Project number: S14045 Letter reference: S14045LT2

UNSW Kensington Campus Noise, Vibration and EMI from Light Rail Review of SLR Modification

Table 1 Summary of "Modification 4" Review Comments

Figure 1 Proposed Relocated Light Rail Location

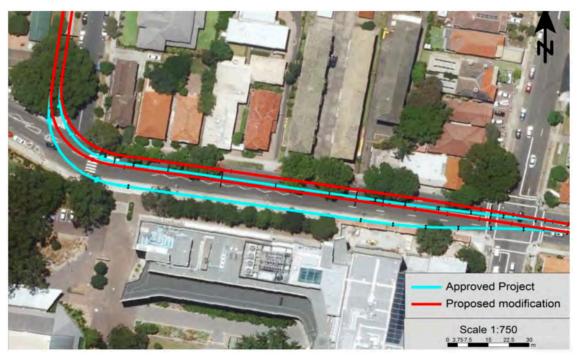
The location of the High Street stop is to be moved away from UNSW as part of this proposed modification as shown in the Figure 1.

Point	Management Plan (section and relevant text)	Response
1	CSELR Main Report General	The key features relevant to the UNSW in this modification (from a vibration, noise and EMI perspective) are:
		 Tram track moved further away from the Lowy Building Likely reduction of noise, vibration and EMI from the proposed Light Rail
		While there is some mention of the UNSW there is no specific consideration of Approval Conditions B17 and B18. This needs to be addressed (in a separate document) so that UNSW specific concerns are mitigated to a suitable level.
		While the Lowy Building is stated to be sensitive, the Wallace Wurth Building is also sensitive and should be addressed. This aspect is particularly critical for sensitive equipment such as Electron Microscopes and/or Animal Research Facilities.
